Inspection Summary

Permit #: PRRES20200322 Address: 2029 NE BLUESTONE DR, LEES SUMMIT, MO 64064

Re: Lot 322 Park Ridge 2029 NE Bluestone Dr

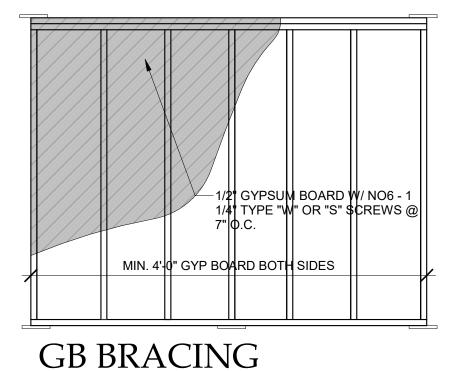
The side to side braced wall lengths have been reduced by adding a 12' slider to the covered rear deck. After reviewing the side-to-side firm recommends installing GB Bracing to the front side-to-side wall of the Master Bedroom and the rear side-to-side wall of the Garage. (see attached)
